## INTERNATIONAL PRELIMINARY EXAMINATION REPORT

Applicant's or agent's file reference FP18527	<b>FOR FURTHER ACTION</b> See Notification of Transmittal of International Preliminary Examination Report (Form PCT/IPEA/416).	
International Application No. <b>PCT/AU2003/001300</b>	International Filing Date (day/month/year) 2 October 2003	Priority Date (day/month/year) 2 October 2002
International Patent Classification (IPC) or national classification and IPC <b>Int. Cl. 7 E04C 3/294, E04B 5/32</b>		
Applicant <b>UNIVERSITY OF WESTERN SYDNEY et al</b>

Fig. 6.

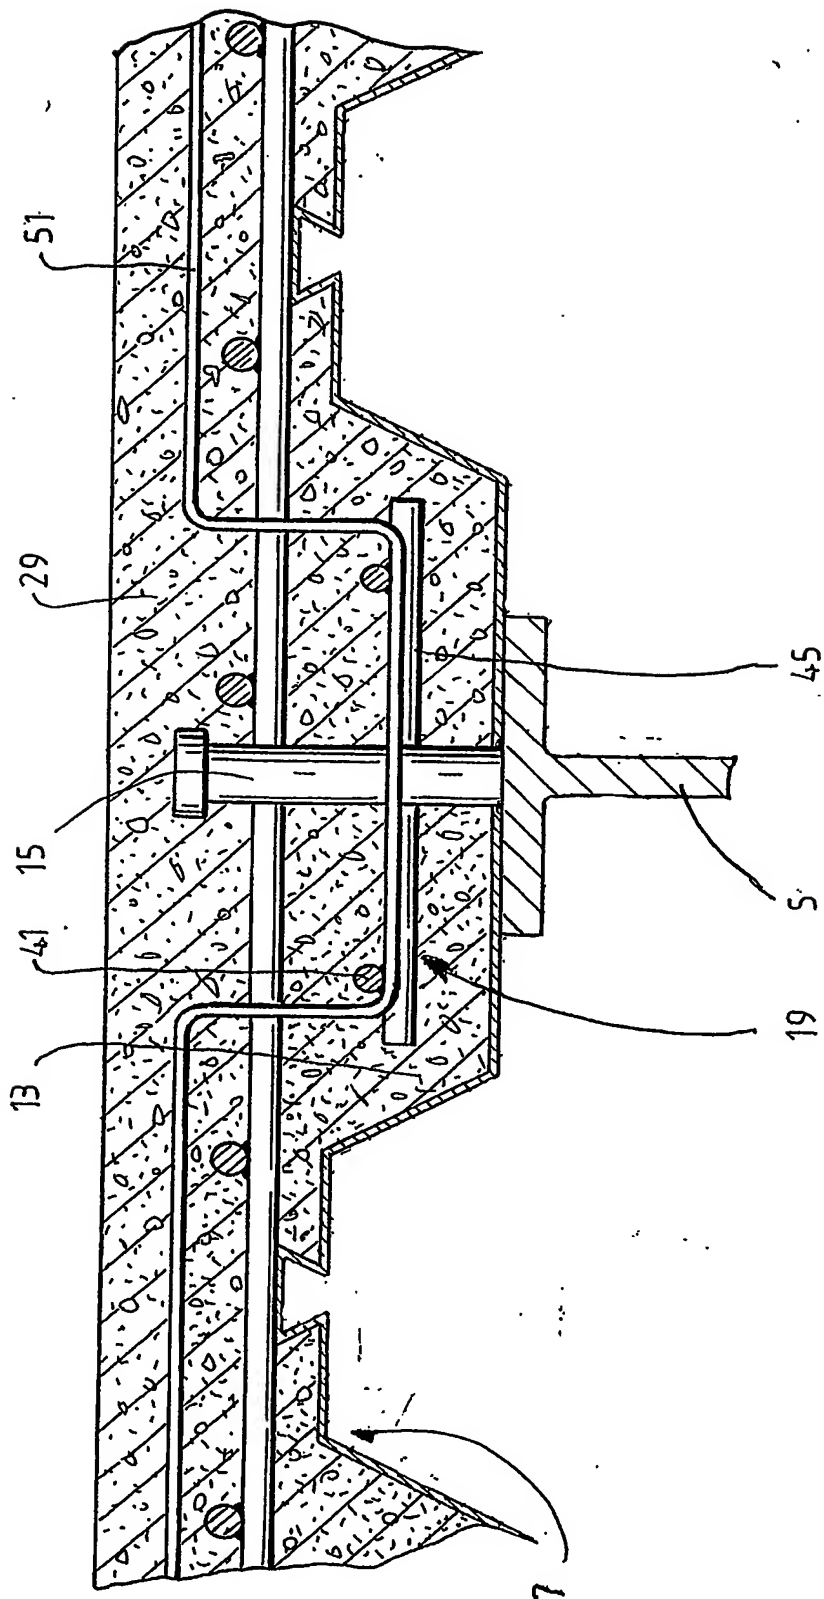
Claim 7, defines that the mesh extends across the width of the concrete rib at the position of the mesh in the concrete rib. D1) shows this at Fig 6. D2) shows this at Fig 2, at the base of the mesh.
